CORRIGENDA

The structure and development of a wing-tip vortex

Journal of Fluid Mechanics, vol. 312 (1996), pp. 67–106

FIGURE 19 (corrected). Development of tangential velocity profiles in the baseline flow computed assuming laminar flow starting with the measured profile at $x/c = 5$.

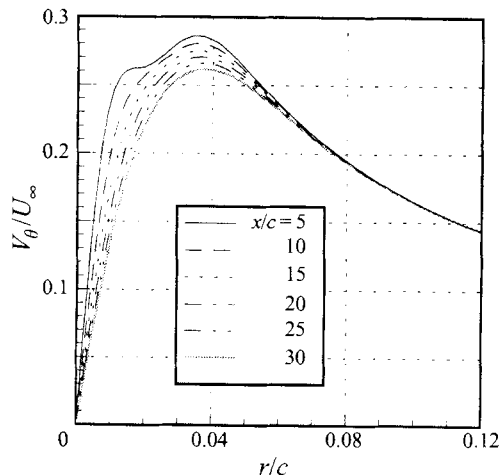
Owing to a programming error, figure 19 on page 91 of this paper is incorrect and should have appeared as shown here. The figure shows predictions of the decay of the tangential velocity profile of the tip vortex assuming laminar cylindrical flow. The corrected figure shows much closer agreement with the experimental data, particularly at the most downstream locations, $x/c = 25$ and 30 . This strengthens the main conclusion of the paper that the vortex core is indeed laminar.
